Submitted To:
*Ohio Department
of Transportation*

Final Alternative Technical Concepts (ATC) Submittal
BEL-70-9.35 Interchange Improvement
Design-Build
Belmont County, Ohio
PID 120547

SCHEMATIC PLAN
STA. 125+00 TO END

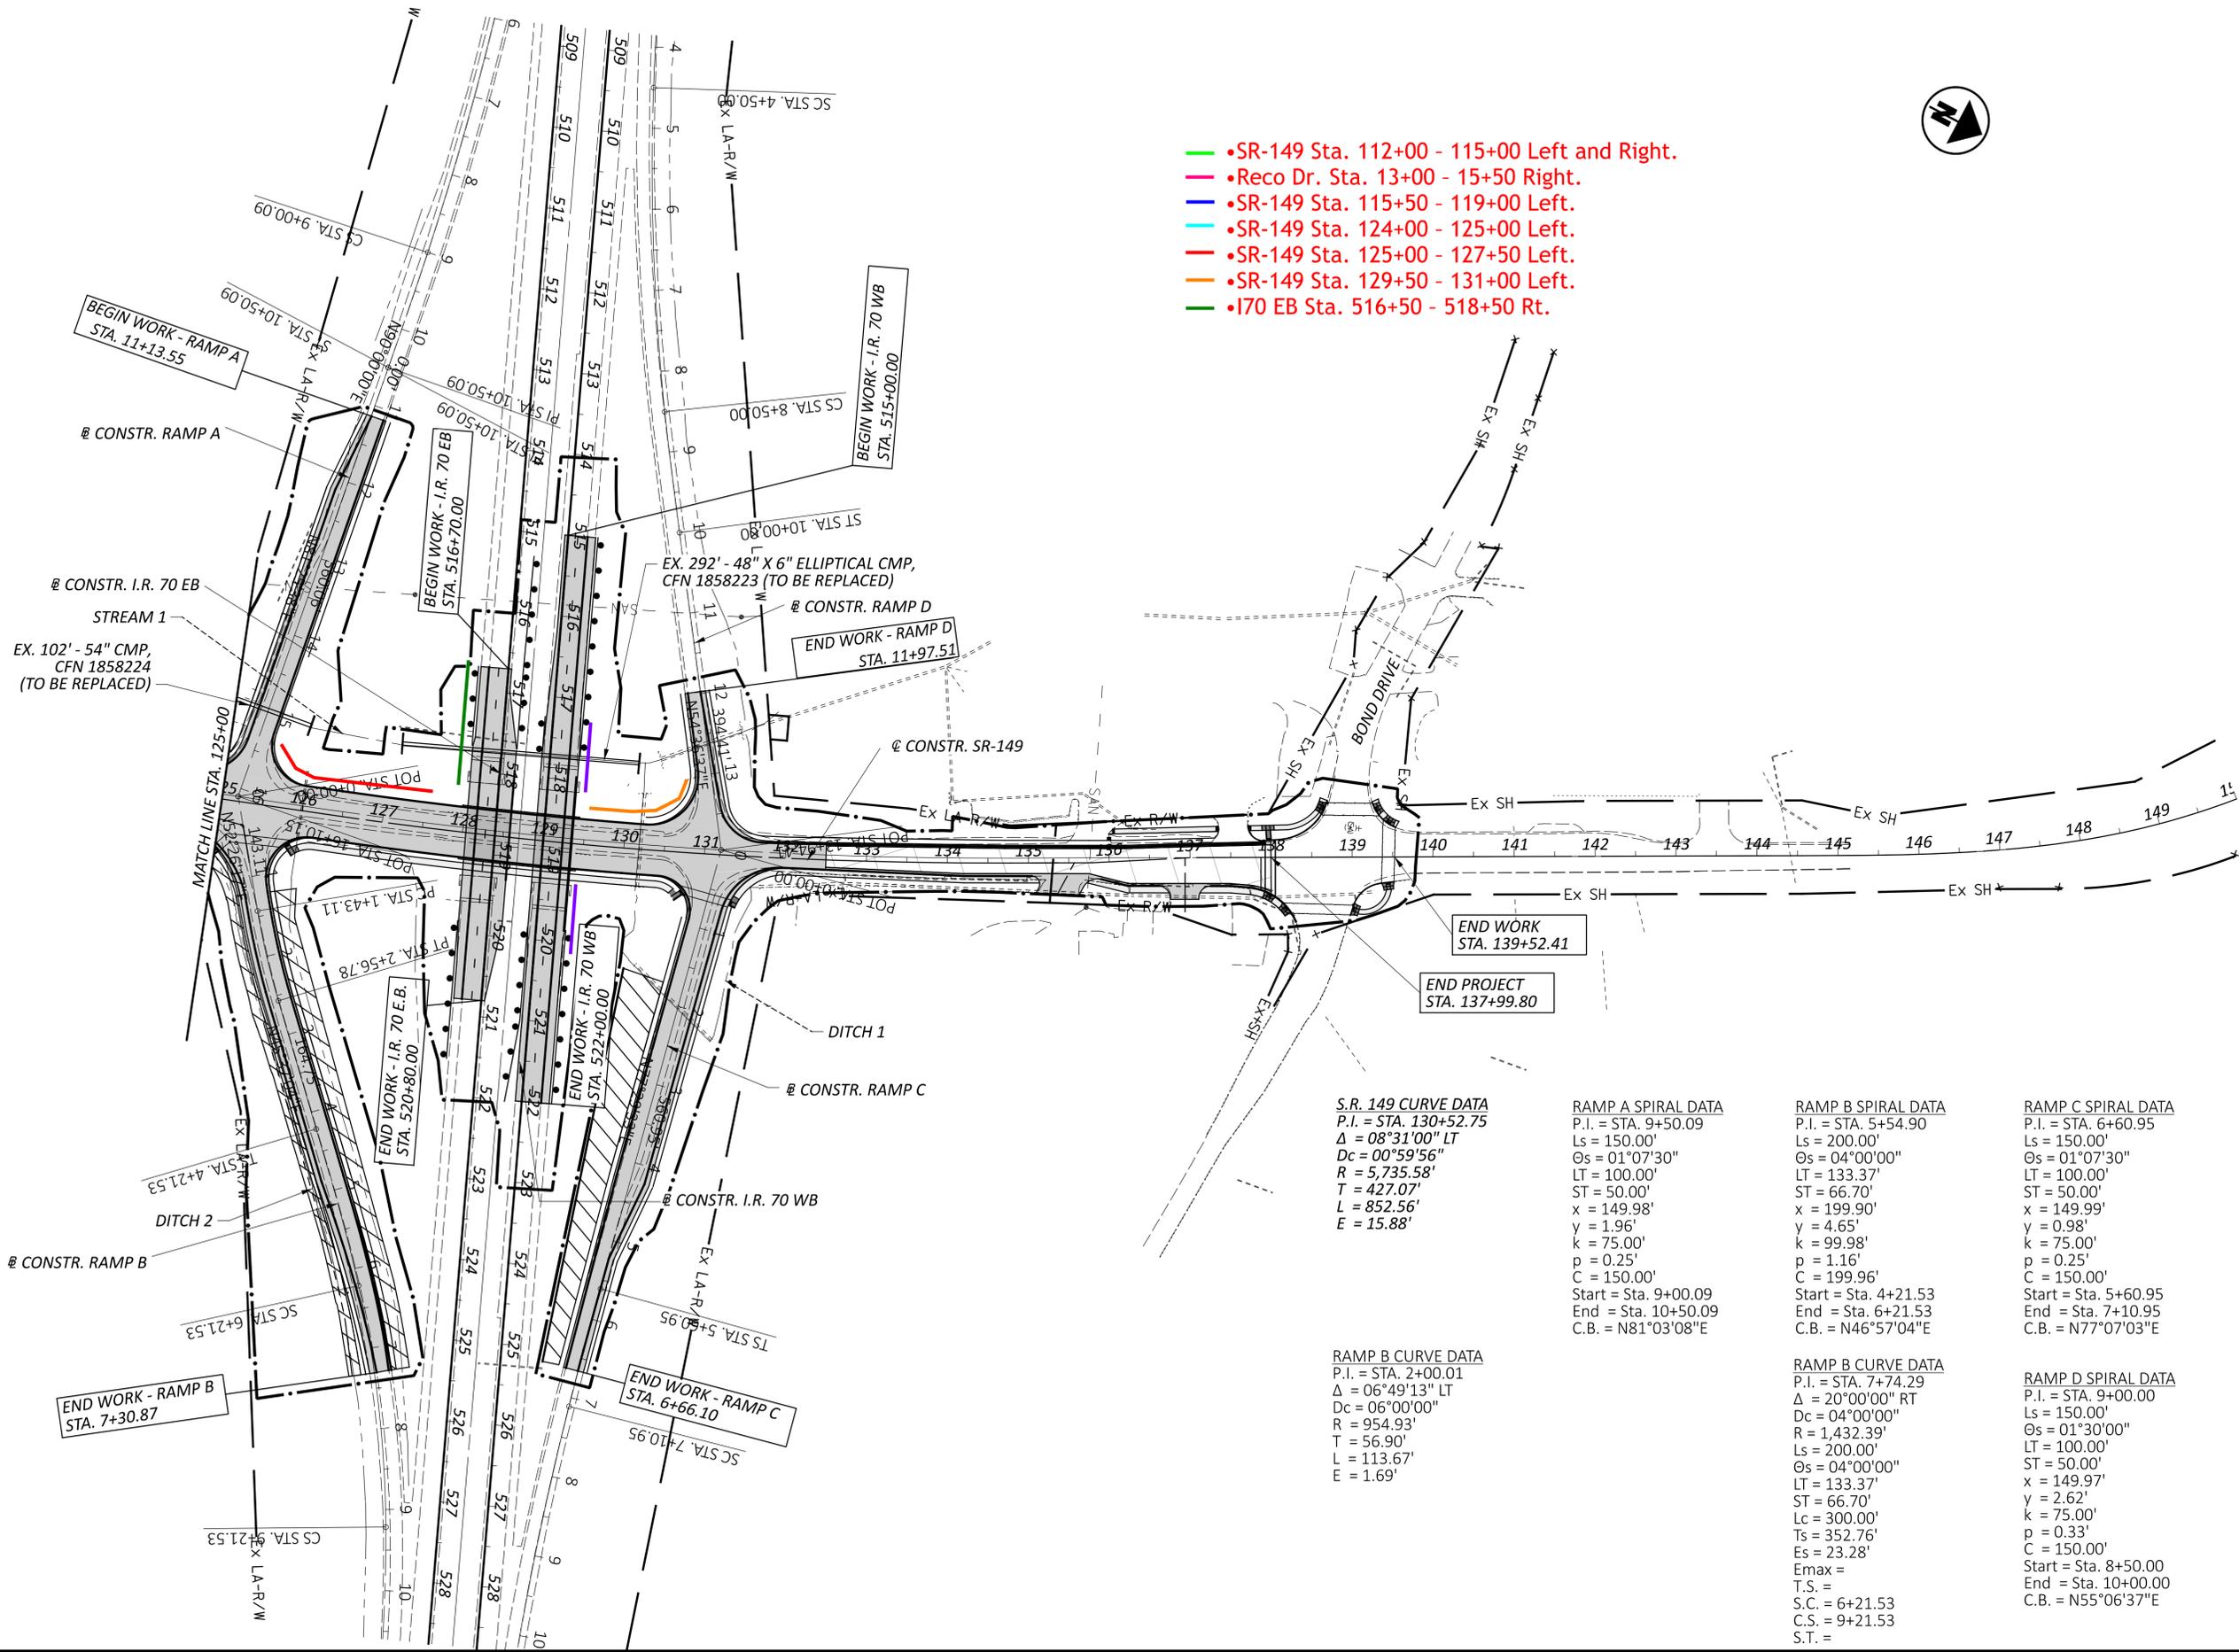
- SR-149 Sta. 112+00 - 115+00 Left and Right.
- Reco Dr. Sta. 13+00 - 15+50 Right.
- SR-149 Sta. 115+50 - 119+00 Left.
- SR-149 Sta. 124+00 - 125+00 Left.
- SR-149 Sta. 125+00 - 127+50 Left.
- SR-149 Sta. 129+50 - 131+00 Left.
- I70 EB Sta. 516+50 - 518+50 Rt.

The DBT proposes to modify the above language to: "*The maximum side-slopes along SR-149, Reco Drive, and the ramps shall be 2:1. A 1:5 slope may be used along IR-70 near the proposed approach slabs and bridge abutments, and a 1.5:1 slope at the following locations:*"

- SR-149 Sta. 112+00 - 115+00 Left and Right
- Reco Dr. Sta. 13+00 - 15+50 Right
- SR-149 Sta. 115+50 - 119+00 Left
- SR-149 Sta. 124+00 - 125+00 Left
- SR-149 Sta. 125+00 - 127+50 Left
- SR-149 Sta. 129+50 - 131+00 Left.
- I70 EB Sta. 516+50 - 518+50 Rt.

1.5:1 may be steepened to 1:1 in locations above to minimize the impacts to existing culverts, drainage, wetlands, or utilities. All side slopes must comply with ODOT SS863 and Geotechnical Design Manual 502.2 requirements."
